ATLAS-CAMPASPE MINERAL SANDS PROJECT OPTIMISATION MODIFICATION

SUBMISSIONS REPORT

OCTOBER 2019
Project No. CMA-18-07
Document No. 00995627-006

REVISED ATLAS-CAMPASPE MINE GENERAL ARRANGEMENT

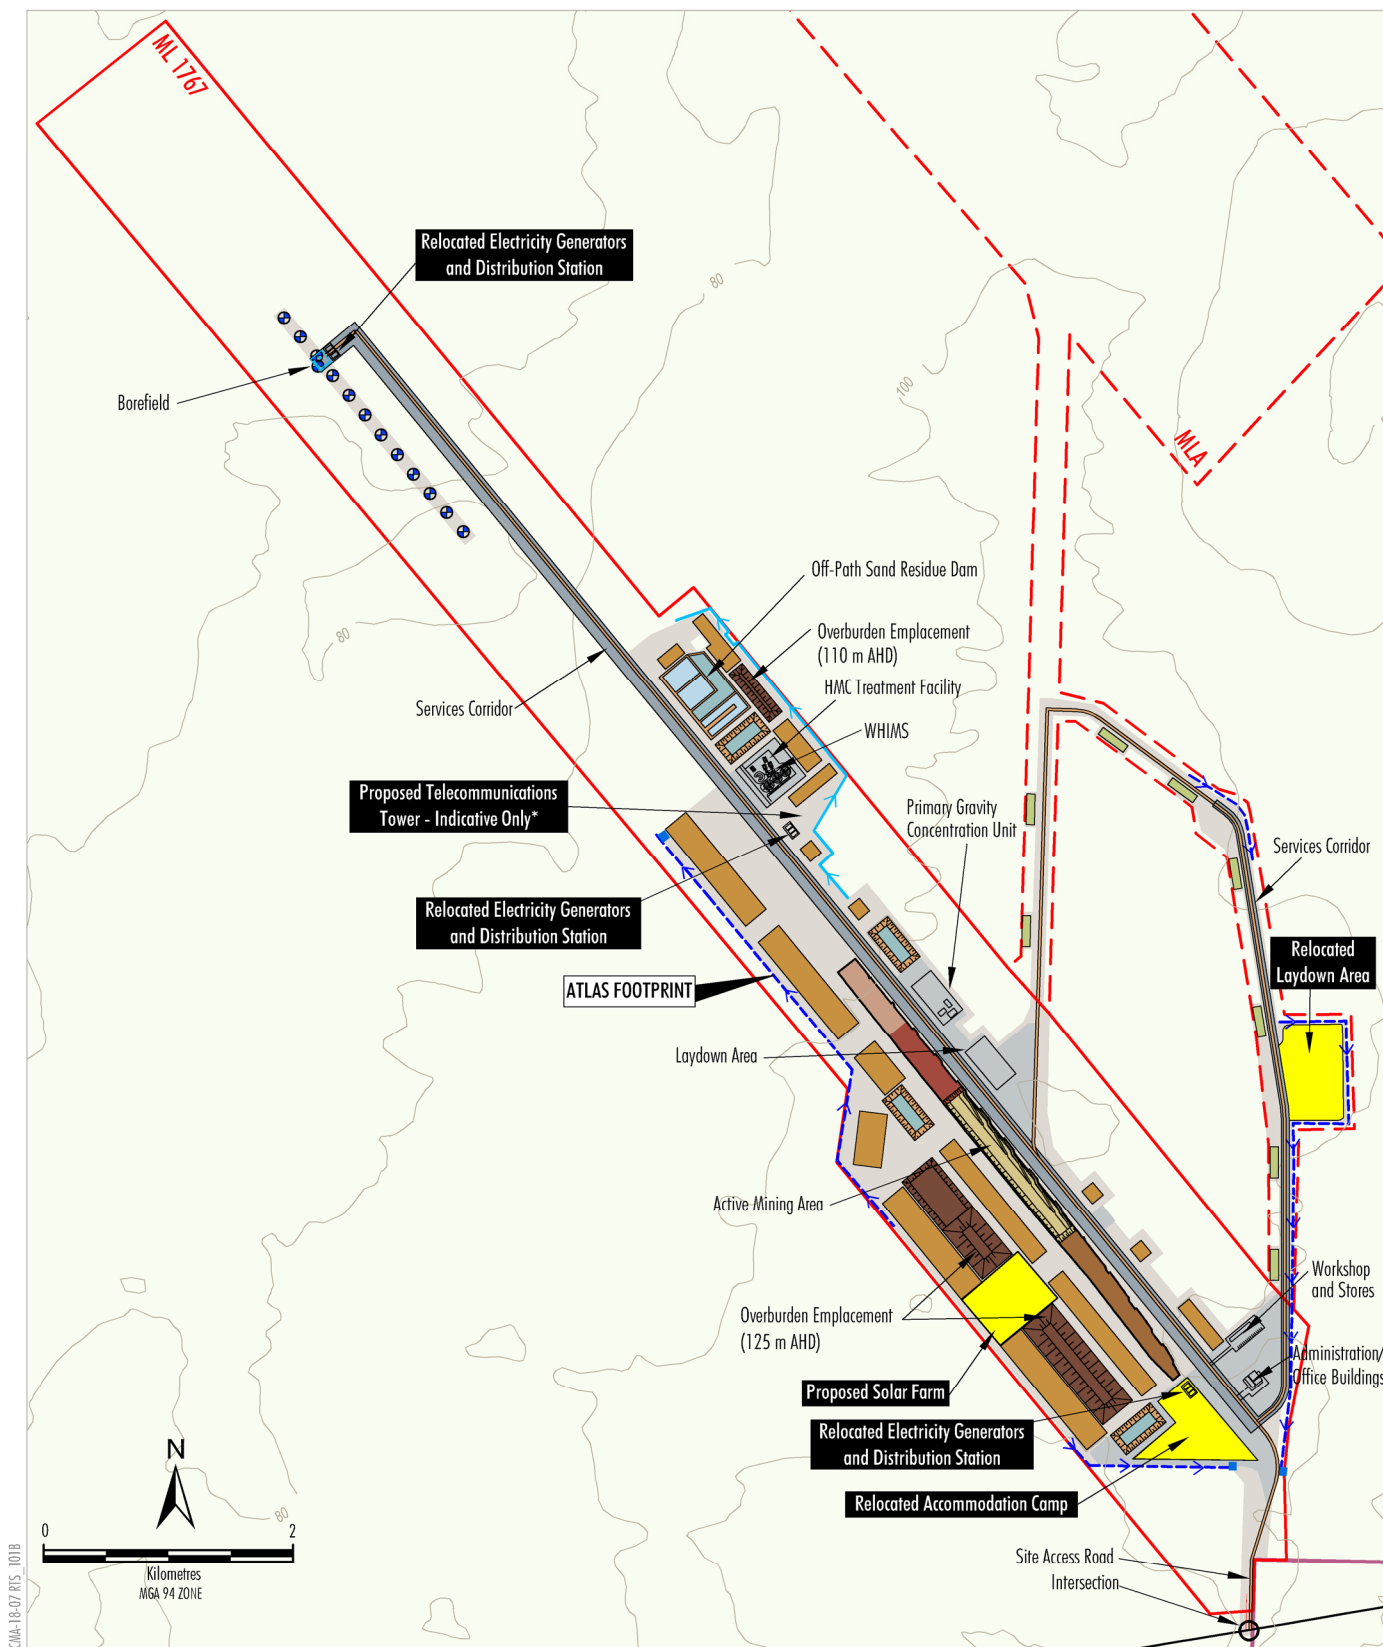
Further Project planning undertaken by Tronox (following submission of the Modification Report) has identified an existing/alternative emergency airstrip located in close proximity to the Atlas-Campaspe Mine on Tronox-leased land. Utilisation of the existing emergency airstrip will provide a more cost-effective solution for the Project. Accordingly, the emergency airstrip described in Section 2.1.8 of the Modification Report is no longer proposed as part of the Modification.

A revised/modified Atlas-Campaspe Mine general arrangement excluding the emergency airstrip is provided in Appendix E.
